DEVELOPMENT DETERMINATION PANEL MEETING

WEDNESDAY 8 JUNE 2022

Agenda for a Meeting of the Development Determination Panel to be held on Wednesday 8 June 2022 Commencing at 10:00am

ITEM 3.1	**DA2021/1487 - 35 BUNGAN HEAD ROAD NEWPORT - DEMOLITION WORKS AND CONSTRUCTION OF A DWELLING HOUSE, INCLUDING AN OUTBUILDING AND A SWIMMING POOL**
REPORTING MANAGER	**STEVE FINDLAY**
TRIM FILE REF	**2022/333071**
ATTACHMENTS	**1 ⇩DDP Mintues - 13 April 2022** **2 ⇩Supplementary Memo** **3 ⇩Site Plan and Elevations**

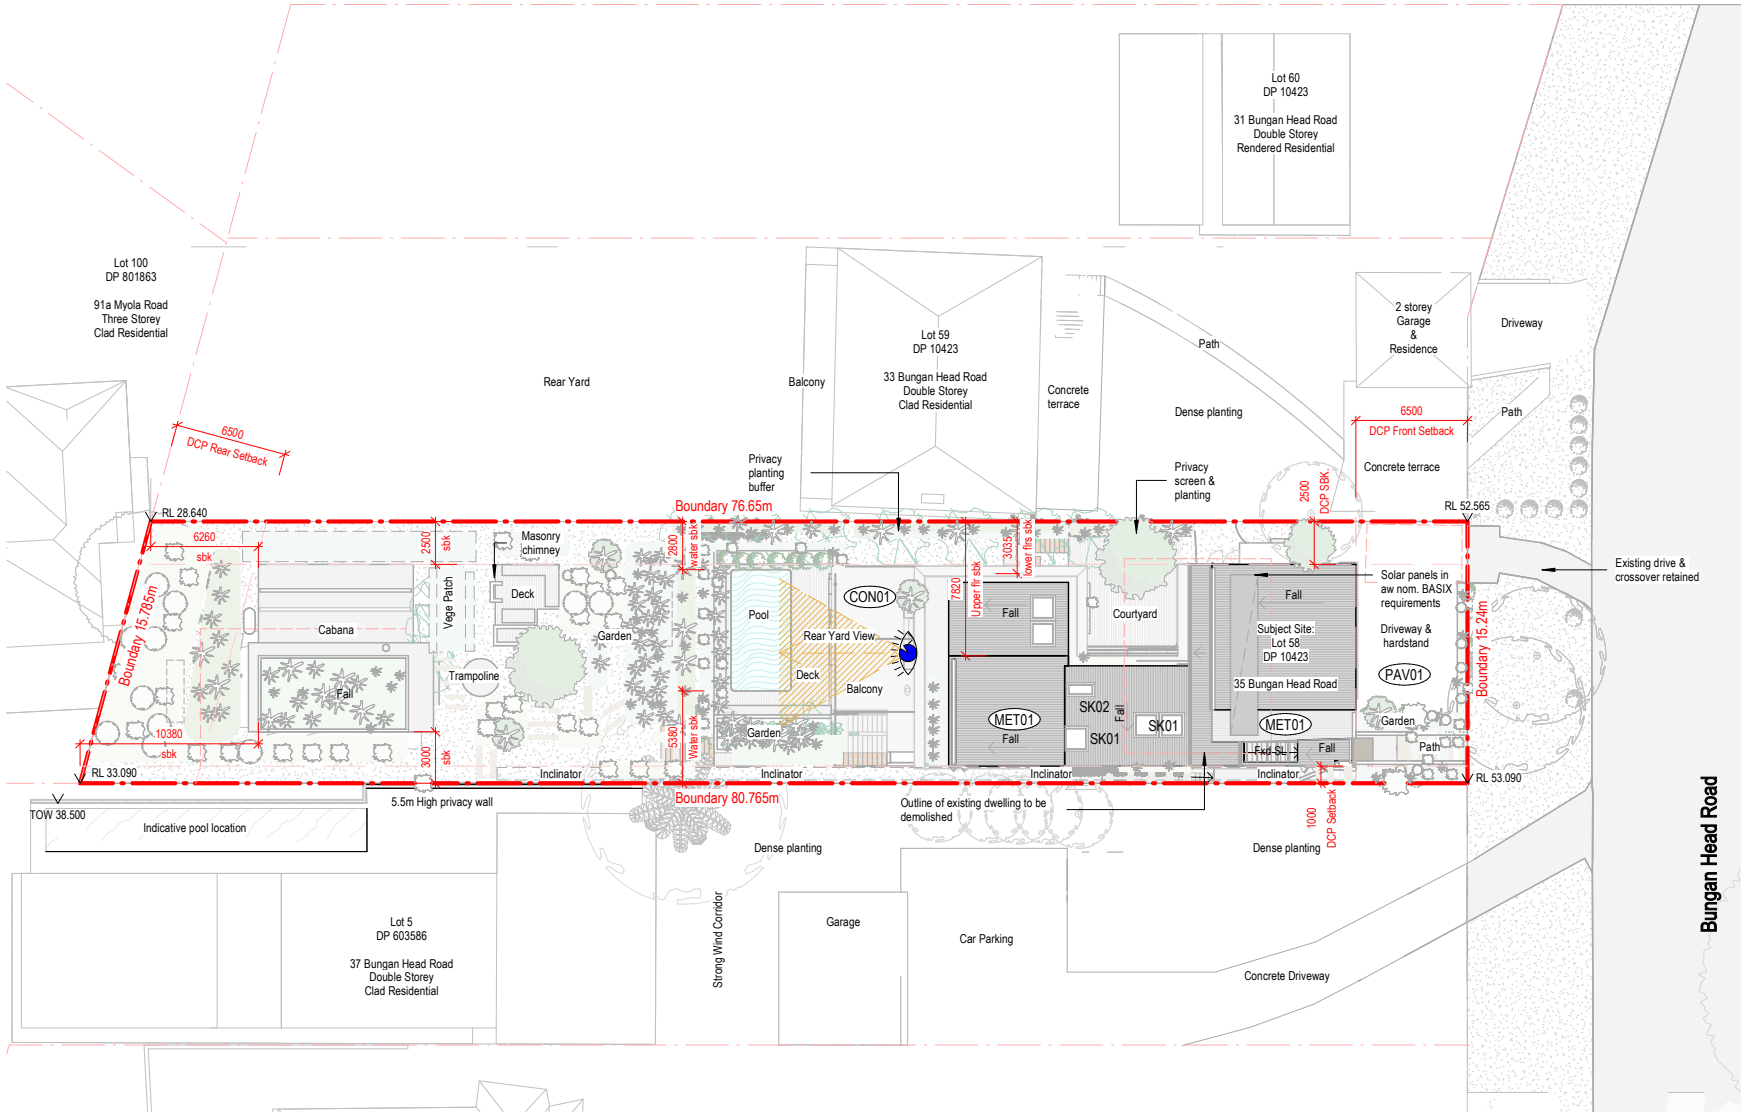
- The southern (rear) portion of the garage has a reduced roof height from RL54.71 to RL54.41. The below sectional drawing by the project architect shows the reduced roof height, noting that the previous outer roof edge ran at the same level as the top of the lift-shaft.

- The footprint, location and layout of the garage has not changed.
- The applicant contends that no unreasonable view loss occurs consequent of the garage.
- The outbuilding subject of Condition 10(a) has been reduced in internal area from 65.55m$_2$ to 59.9m^2. The room annotations have changed from '*living, kitchenette, bath, bed 1 and bed 2*' to '*rumpus, bath, home office'*. The plans have removed the kitchenette area.
- The applicant has elected to retain the two-storey component of the outbuilding by retaining the studio on Level 1. The deck area adjacent to the studio has been reduced in depth by the installation of planter boxes inward of the outermost western edge.

Drawing
Cabana Proposed - North & South Elevations

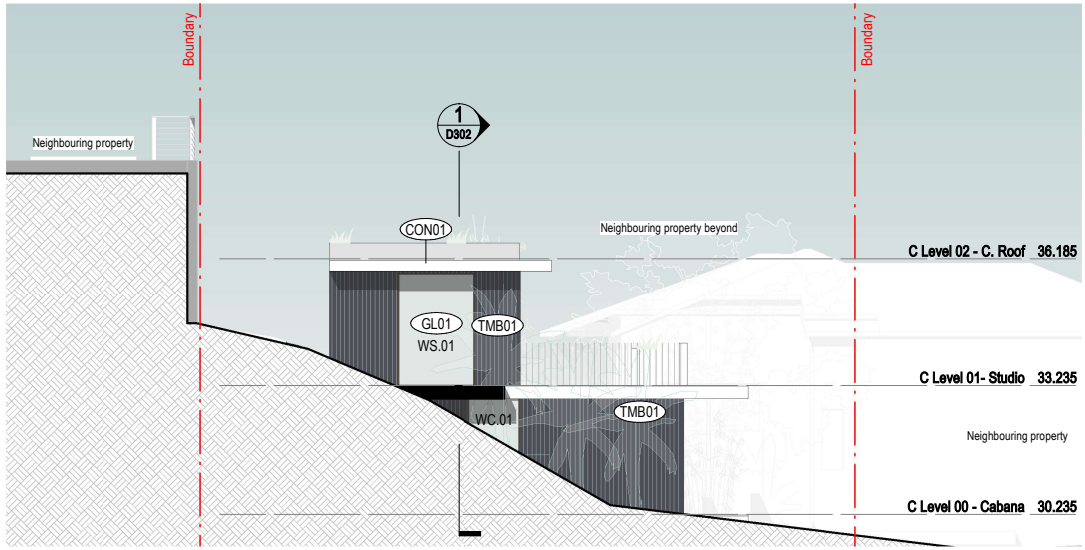
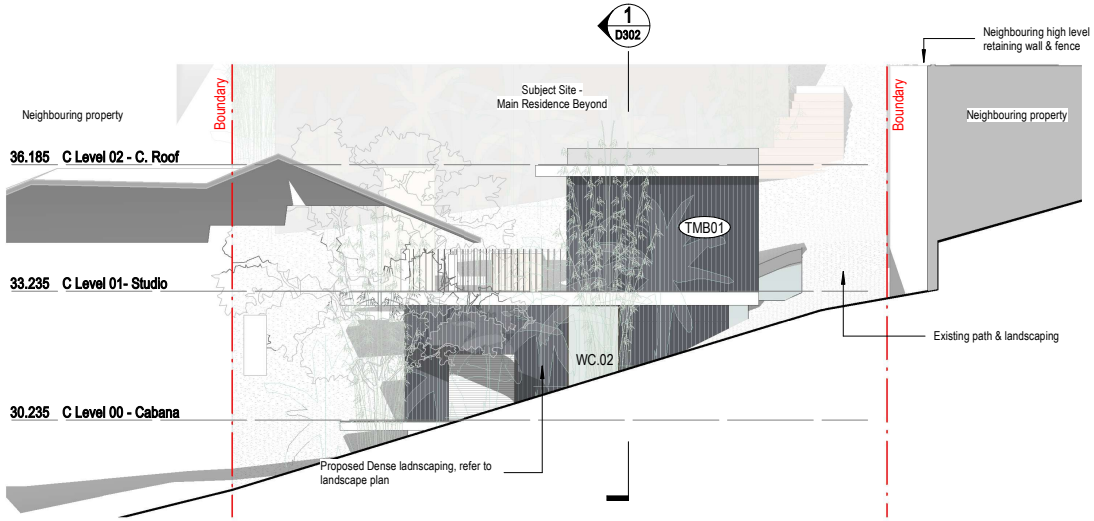
In this regard, the panel agrees that the structure should be deleted as stipulated by Condition 10 a, or alternatively the applicant can submit a revised scheme for a single storey structure that meets the requirement of Clauses C1.11 and C1.14 of Pittwater 21 DCP and compliance with the rear setback control is achieved.

- ***Garage / view impacts***
  - *Southern edge of garage roof lowered 300mm*
  - *View analysis provided for revised proposal*
- ***"Separately accessible structure"***
  - *Cabana floor plan reduced to <60sqm*
  - *All setbacks comply*

- *Internal arrangement and intended function aligns with C1.14 i.e. office, rumpus, toilet, studio and, critically, no sleeping quarters*
- *Studio volume shifted west over floor below such that eastern elevation of studio and ground level of the "separately accessible structure" aligns*
- *Perimeter planting added and deck area reduced to mitigate potential for cross-viewing*

> ***10. Amendments to the approved plans***
>
> *The following amendments are to be made to the approved plans:*
>
> *a. The two storey cabana/outbuilding located to the southern end of the site is to be deleted in its entirety. No ground works, excavation or vegetation removal on the footprint of this structure is authorised under this consent.*
>
> *b. The inclinator and its associated landings are to be deleted from the plans*
>
> *c. Planter box(es) are to be installed for along the outermost western edge of the deck accessible from the kitchen and living room for the full width of the deck. The planter box(es) are to have a minimum internal dimension of 1.0m and shall be constructed or installed to a minimum height of 1.0m above finished floor level. The planter box(es) are to be planted with native species capable of reaching a height between 1.0m and 1.5m at maturity.*
>
> *d. A fence or screen that is non-transparent is to be erected along the outermost western edge of the swimming pool deck to a height of 1.7m measured from finished floor level.*

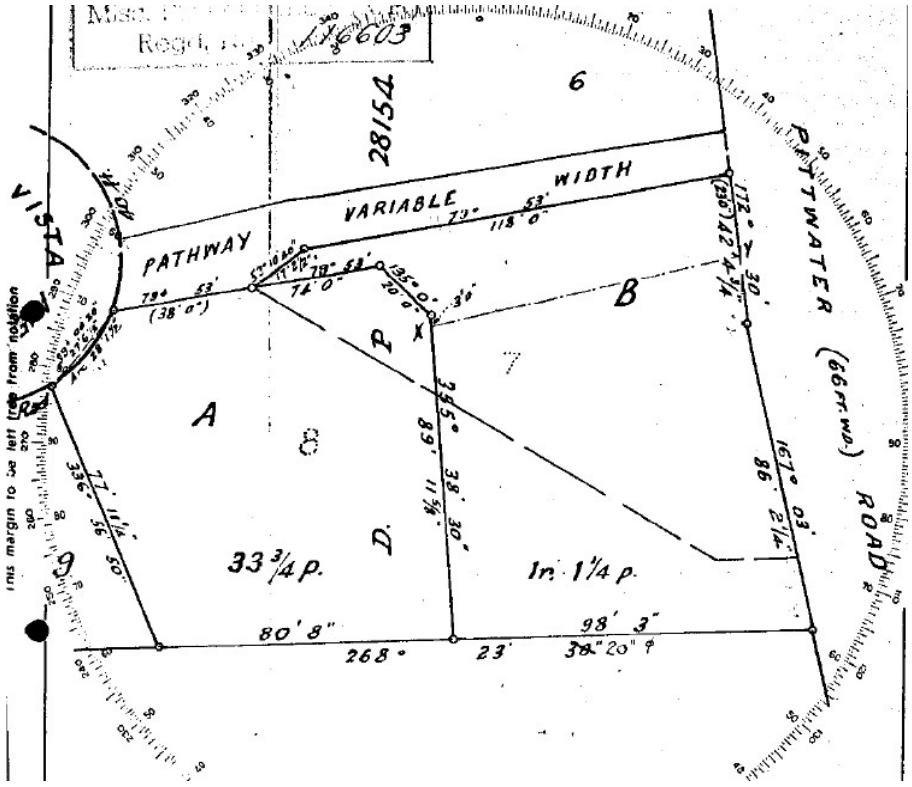
(a) That no building or structure ill be erected North of a line parallel with and 9 feet south of the line marked X-Y on the said plan.

It is understood (but not confirmed) that the original purpose of this covenant was to retain a view corridor from No. 11 Vista Avenue to the west ('A' on the diagram) over the site and towards Bayview.

The covenant is understood to have been made in a civil capacity and was not imposed or required to be imposed by Council. The covenant does not constitute a Planning Agreement.

The covenant restricts the carrying out of development on a portion of the site, however that restriction is not consistent with the requirements of the relevant environmental planning instruments.
